Source: TSG CN WG1
Title: CR to Rel-6 WI "MBMS" and "TEI6" for TS 24.008
Agenda item: 9.8
Document for: APPROVAL

This document contains 3 **CRs on Rel-6 Work Item "MBMS" and "TEI6"**, that have been agreed by TSG CN WG1 CN#37 meeting and forwarded to TSG CN Plenary meeting #27 for approval.

⌘ **24.008 CR 931** ⌘ rev **1** ⌘ Current version: **6.7.0** ⌘

Title:	⌘ Synchronization of MBMS context status between UE and SGSN		
Source:	⌘ Siemens AG		
Work item code:	⌘ MBMS	Date:	⌘ 15.02.2005
Category:	⌘ B	Release:	⌘ Rel-6
	Use <u>one</u> of the following categories: F (correction) A (corresponds to a correction in an earlier release) B (addition of feature), C (functional modification of feature) D (editorial modification) Detailed explanations of the above categories can be found in 3GPP TR 21.900 .		Use <u>one</u> of the following releases: Ph2 (GSM Phase 2) R96 (Release 1996) R97 (Release 1997) R98 (Release 1998) R99 (Release 1999) Rel-4 (Release 4) Rel-5 (Release 5) Rel-6 (Release 6) Rel-7 (Release 7)

Figure 6.1a/3GPP TS 24.008: Session management states for MBMS context handling in the MS (overview)

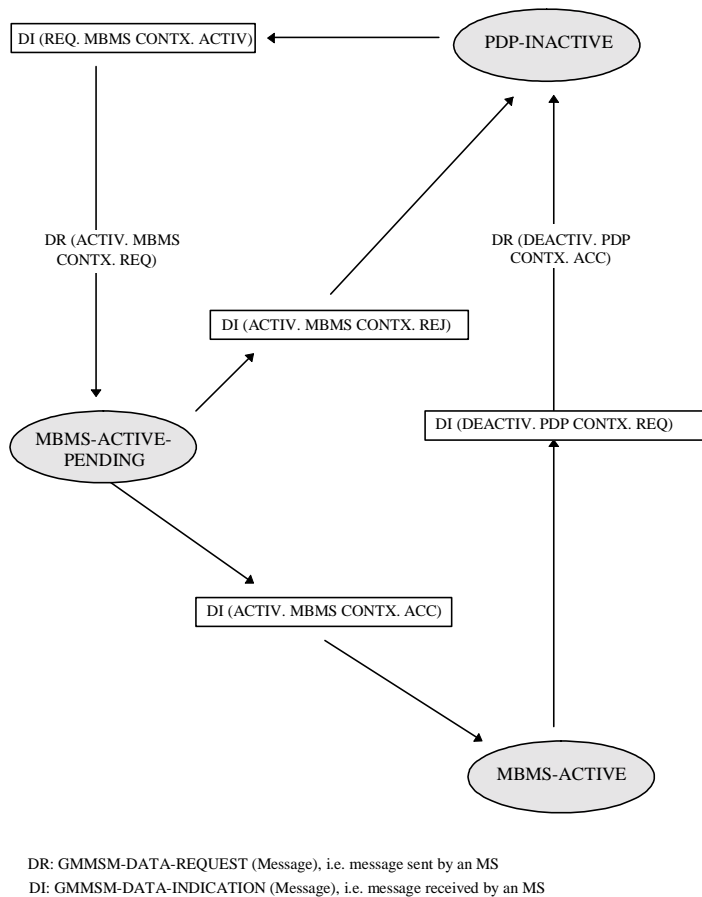
Summary of change:	⌘ It is proposed to move the sub-clauses of chapter 6.2 to the appropriate sub-clauses in chapter 6.1. The state MBMS-INACTIVE is proposed to be deleted, as for an inactive context no distinction between PDP and MBMS could be made. It is proposed to get rid of the terms "MBMS protocol", "MBMS Session Management" and "MBMS protocol" (e.g. in the timer sub-clause 11.2.3). It is proposed to move the description of the new MBMS specific SM cause to I.1 and to delete I.3. State diagrams for the MBMS context handling are introduced.
